**SUBDIVISION &  
PLANNED UNIT DEVELOPMENT  
STAFF REPORT**

**Date: October 6, 2022**

<b><u>DEVELOPMENT NAME</u></b>	Sunset Creek Subdivision
<b><u>SUBDIVISION NAME</u></b>	Sunset Creek Subdivision
<b><u>LOCATION</u></b>	3250 Spanish Alley (North terminus of Spanish Alley, between Halls Mill Creek and Riviere du Chien Road).
<b><u>CITY COUNCIL DISTRICT</u></b>	District 4
<b><u>AREA OF PROPERTY</u></b>	3 Lots / 7.5± Acres
<b><u>CONTEMPLATED USE</u></b>	Subdivision approval to create three (3) legal lots of record from three (3) legal lots of record and a portion of existing right-of-way; and Planned Unit Development approval to allow a gated, private street single-family residential subdivision.
<b><u>TIME SCHEDULE FOR DEVELOPMENT</u></b>	Not provided

# DETAIL SITE PLAN

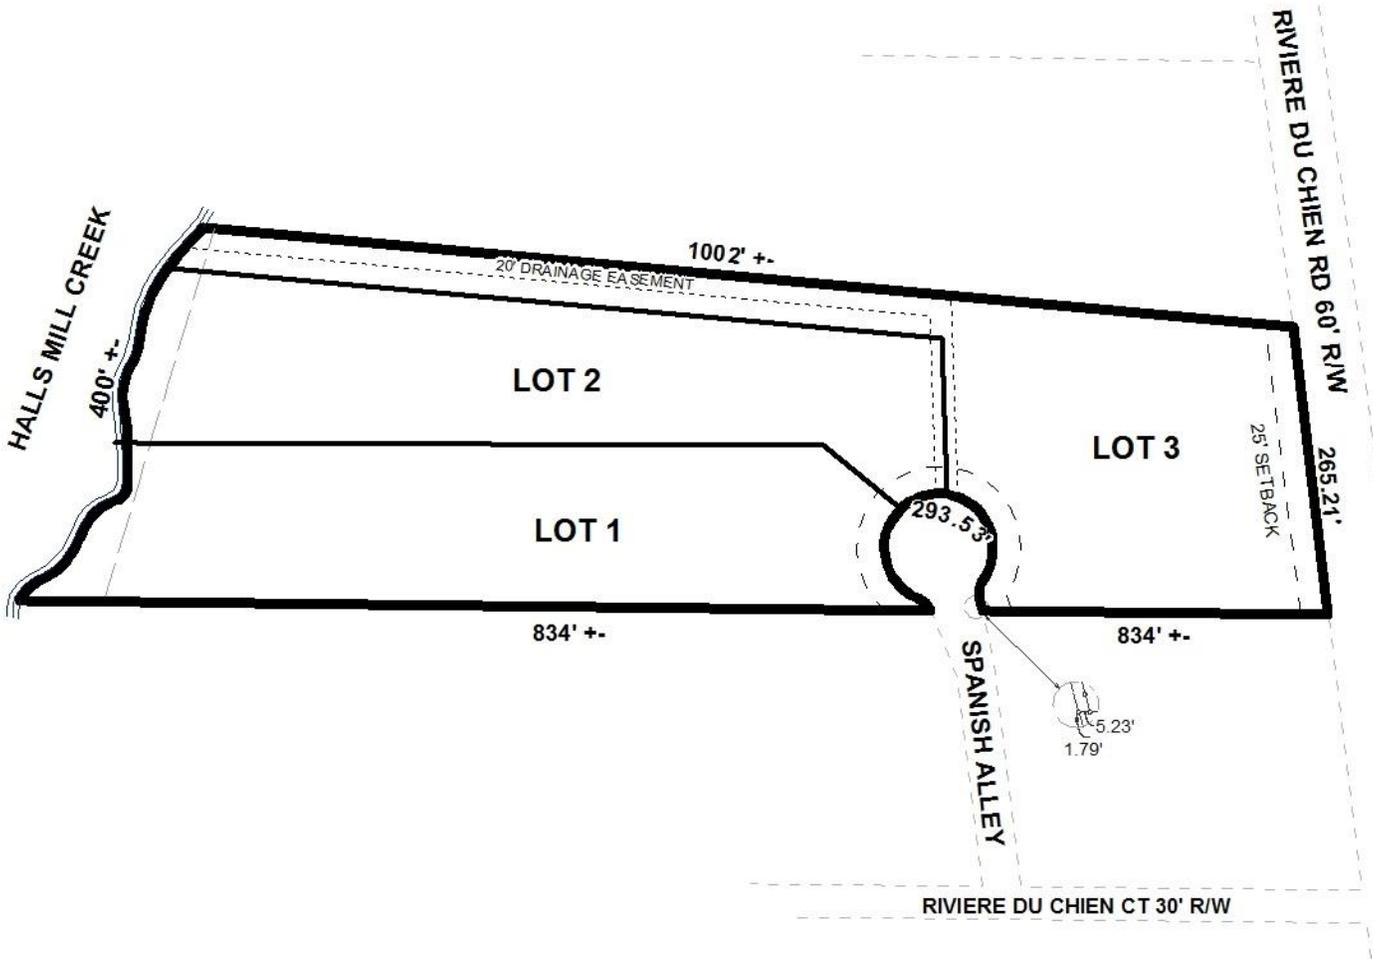
**Subdivision:** The “PLAT” that was submitted is labeled BOUNDARY & STAKEOUT SURVEY (dated 5/11/21) and is not legible for review.

Design of access from the private street to the north terminus of Spanish Alley to be approved by Traffic Engineering and conform to AASHTO standards. Terminating the public street prior to the cul-de-sac will eliminate the ability for vehicles to turn around at the end of this street.

The applicant did not submit a preliminary plat showing the proposed lot lines and other information as required by Section IV of the Subdivision Regulations for the proposed Subdivision, but rather a survey of the existing property configuration, and an indication as to where the proposed gate will be located. As such, if approved, a Final Plat, compliant with Section IV of the Subdivision Regulations will be required.

Spanish Alley is a minor street without curb and gutter, and has an existing compliant right-of-way per the previous Subdivision approval. However, it should be noted that if the applicant is successful in their attempt to have the Spanish Alley right-of-way vacated, there will not be a compliant turn around area for garbage and trash trucks, fire trucks and other emergency vehicles to safely turn around. Therefore, if approved, the applicant may be required to provide a hammerhead, or other compliant turn around, as required by the Fire Department.

As mentioned, a preliminary plat showing the proposed lot configuration was not submitted with the application, therefore staff is unable to determine how wide the proposed lots will be at their frontages, however as the existing right-of-way width is 47.75± feet wide South of the existing turn around, each lot may only have up to 16± feet of street frontage, considerably less than the 60-feet of street frontage required by Section V.D.2. of the Subdivision Regulations. The existing Lot 3 is the only lot that would have sufficient street frontage, as proposed, as it also fronts Riviere du Chien Road.

As mentioned previously, if the applicant is successful in their attempt to have the cul-de-sac right-of-way vacated, it would eliminate a compliant turn-around area for emergency vehicles, and create lots that have sub-standard street frontage. It should be noted that the applicant could place a fence, with gates, along the existing front property lines of the existing lots. The fence and gates could be either chain link, or wrought iron (with Traffic Engineering approval) up to eight (8) feet high, and would not impede emergency vehicle maneuvering.

**Subdivision:** The application is recommended for Denial, due to the following reasons:

- 1) A plat as required by Section IV.A. of the Subdivision Regulations was not submitted for staff review;
- 2) The proposed Subdivision configuration would result in two of the three proposed lots having sub-standard street frontage; and
- 3) The proposed Subdivision configuration would eliminate a compliant turn-around for public works and emergency vehicles.

- a. the proposal does not promote the objective of Public services (*to encourage optimum use of available public utilities, streets and community facilities*), because the proposed configuration would result in the loss of a compliant turn-around for public works and emergency vehicles.
